#### **Addendum 116 – UN Regulation No. 117**

#### **Revision 4 - Amendment 6**

Supplement 14 to the 02 series of amendments – Date of entry into force: 8 October 2022.

#### **Uniform provisions concerning the approval of tyres with regard to rolling sound emissions and/or to adhesion on wet surfaces and/or to rolling resistance**

## "Annex 2 - Appendix 1

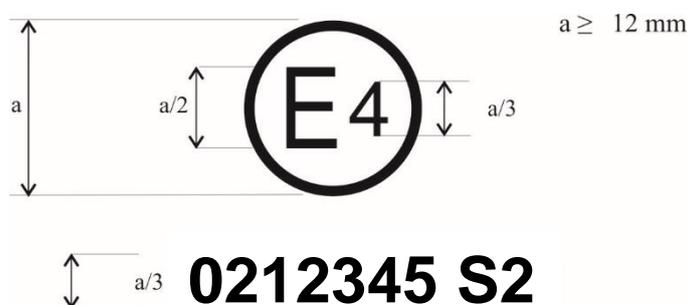
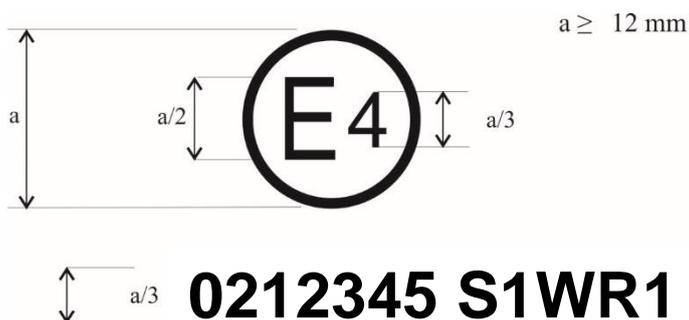
Annex 2 - Appendix 1, amend to read:

The above approval mark, affixed to a tyre shows that a tyre concerned has been approved in the Netherlands (E 4) pursuant to Regulation No. 117 (marked by "S2"), under approval number 0212345. This indicates that the approval is for rolling sound at stage 2 (S2). The first two digits of the approval number (02) indicate that the approval was granted in accordance with this Regulation which included 02 series of amendments.

The above approval mark shows that the tyre concerned has been approved in the Netherlands (E 4) pursuant to Regulation No. 117 (marked by "S1WR1") under approval number 0212345. This indicates that the approval is for rolling sound at stage 1 (S1), wet adhesion (W) and rolling resistance at stage 1 (R1). The first two digits of the approval number ("02") indicate that the approval was granted in accordance with this Regulation which included the 02 series of amendments."

## "Annex 2 - Appendix 2

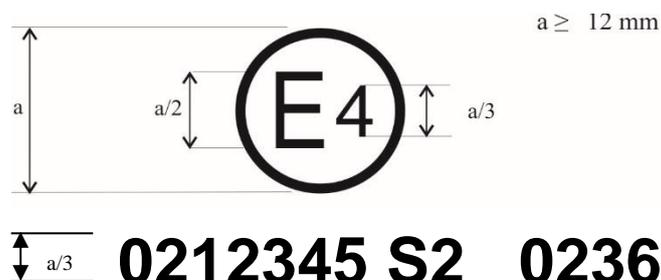
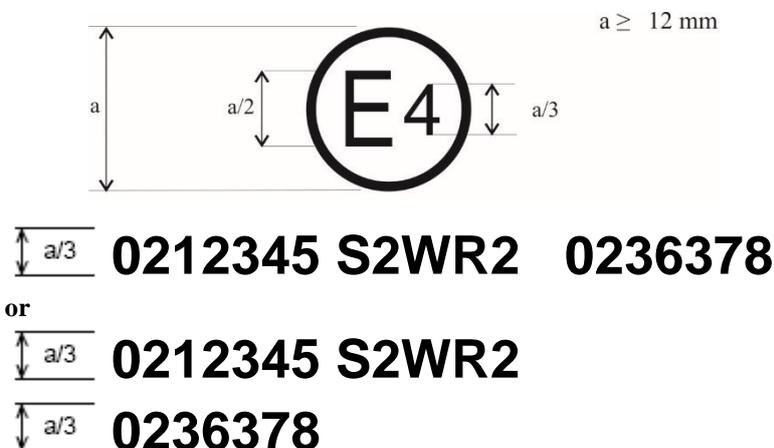
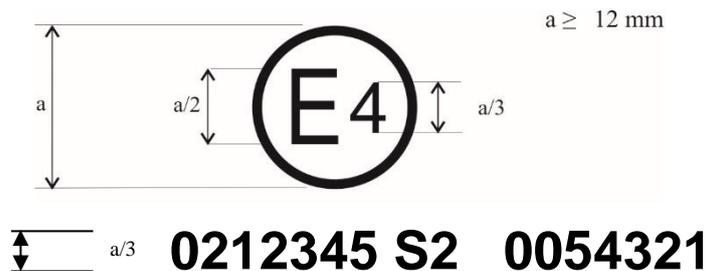
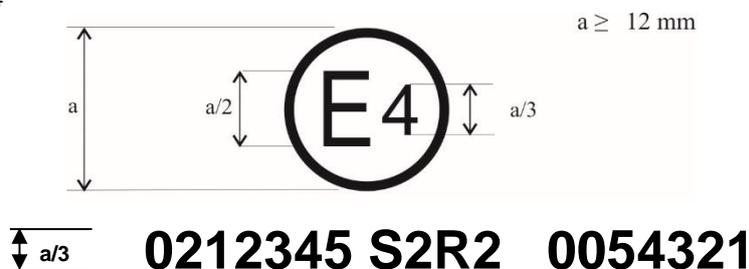
Annex 2 - Appendix 2, delete footnote 1 and amend to read:

The above approval mark shows that the tyre concerned has been approved in the Netherlands (E 4) pursuant to UN Regulation No. 117 (marked by "S2"), under approval number 0212345 and UN Regulation No. 30, under approval number 0236378. This indicates that the approval is for rolling sound at stage 2 (S2). The first two digits of the approval number ("02") in conjunction with "S2" indicate that the approval was granted in accordance with UN Regulation No. 117 which included the 02 series of amendments. The first two digits of the UN Regulation No. 30 approval number ("02") indicate that this Regulation included the 02 series of amendments.

The above approval mark shows that the tyre concerned has been approved in the Netherlands (E 4) pursuant to UN Regulation No. 117 (marked by "S2WR2"), under approval number 0212345 and UN Regulation No. 30, under approval number 0236378. This indicates that the approval is for rolling sound at stage 2 (S2), wet adhesion (W) and rolling resistance at stage 2 (R2). The first two digits of the approval number ("02") in conjunction with "S2WR2" indicate that the first approval was granted in accordance with UN Regulation No. 117 which included the 02 series of amendments. The first two digits of the UN Regulation No. 30 approval number ("02") indicate that this Regulation included the 02 series of amendments.

The above approval mark shows that the tyre concerned has been approved in the Netherlands (E 4) pursuant to UN Regulation No. 117 and the 02 series of amendments under approval number 0212345 (marked by "S2"), and UN Regulation No. 54, under approval number 0054321. This indicates that the approval is for rolling sound stage 2 (S2). The first two digits of the UN Regulation No. 117 approval number ("02") in conjunction with "S2" indicate that the first approval was granted in accordance with UN Regulation No. 117 which included the 02 series of amendments. The first two digits of the UN Regulation No. 54 approval number ("00") indicate that this Regulation was in its original form.

The above approval mark shows that the tyre concerned has been approved in the Netherlands (E 4) pursuant to UN Regulation No. 117 and the 02 series of amendments under approval number 0212345 (marked by "S2R2"), and UN Regulation No. 54, under approval number 0054321. This indicates that the approval is for rolling sound stage 2 (S2) and rolling resistance stage 2 (R2). The first two digits of the UN Regulation No. 117 approval number ("02") in conjunction with "S2R2" indicate that the first approval was granted in accordance with UN Regulation No. 117 which included the 02 series of amendments. The first two digits of the UN Regulation No. 54 approval number ("00") indicate that this Regulation was in its original form."

## "Annex 2 - Appendix 3

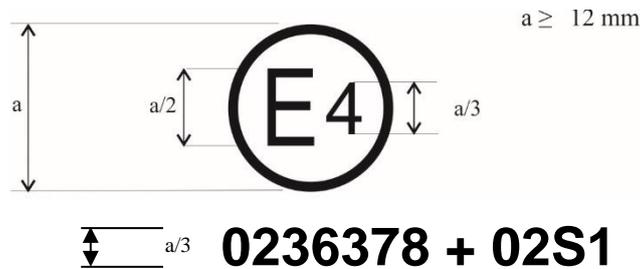
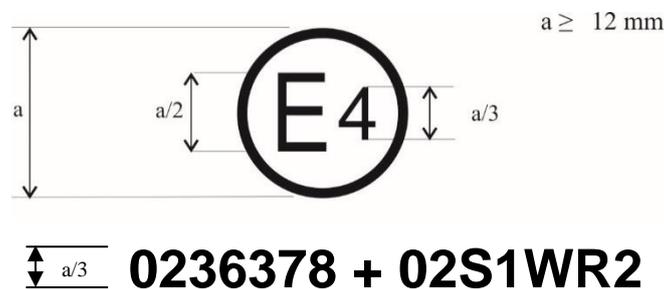
Annex 2 - Appendix 3, amend to read:

The above approval mark shows that the tyre concerned has been approved in the Netherlands (E 4) pursuant to UN Regulation No. 30 according to its 02 series of amendments (indicated by the first two digits of the approval number, "02") under approval number 0236378. It is also marked by "+ 02S1" which indicates that the tyre was also approved pursuant to UN Regulation No. 117 (02 series of amendments) for rolling sound at stage 1.

The above approval mark shows that the tyre concerned has been approved in the Netherlands (E 4) pursuant to Regulation No. 30 according to its 02 series of amendments (indicated by the first two digits of the approval number, "02") under approval number 0236378. It is also marked by "+ 02S1WR2" which indicates that the tyre was also approved pursuant to UN Regulation No. 117 (02 series of amendments) for S1 (rolling sound at stage 1), W (wet adhesion) and R2 (rolling resistance at stage 2)."

## "Annex 2 - Appendix 4

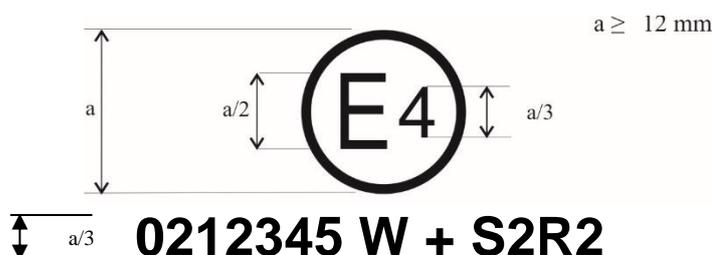
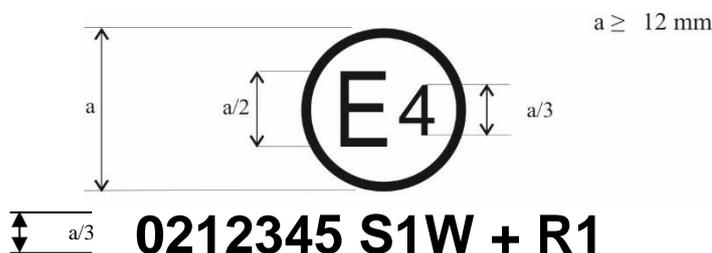
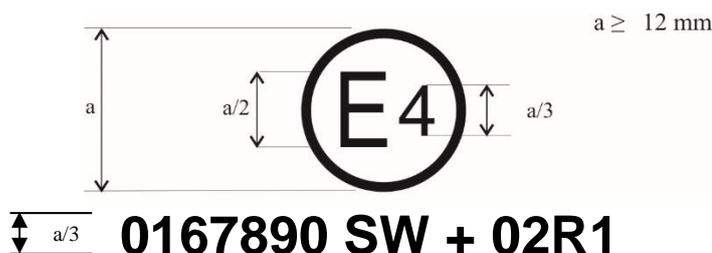
Annex 2 - Appendix 4, delete footnote 1 amend to read:

The above approval mark shows that the tyre concerned has been initially approved in the Netherlands (E 4) pursuant to UN Regulation No. 117 according to its 02 series of amendments (indicated by the first two digits of the approval number, "02") under approval number 0212345 (marked by "W"). This indicates that the approval is for W (wet adhesion). The "S2R2" preceded by "+" indicates that its approval has been extended under UN Regulation No. 117 to rolling sound at stage 2 and rolling resistance at stage 2 based on separate certificate(s).

The above approval mark shows that the tyre concerned has been initially approved in the Netherlands (E 4) pursuant to UN Regulation No. 117 according to its 02 series of amendments (indicated by the first two digits of the approval number, "02") under approval number 0212345 (marked by "S1W"). This indicates that the approval is for S1 (rolling sound at stage 1) and W (wet adhesion). The "R1" preceded by "+" indicates that its approval has been extended under Regulation No. 117 to rolling resistance at stage 1 based on separate certificate(s).

The above approval mark shows that the tyre concerned has been initially approved in the Netherlands (E 4) pursuant to UN Regulation No. 117 according to its 01 series of amendments (indicated by the first two digits of the approval number, "01") under approval
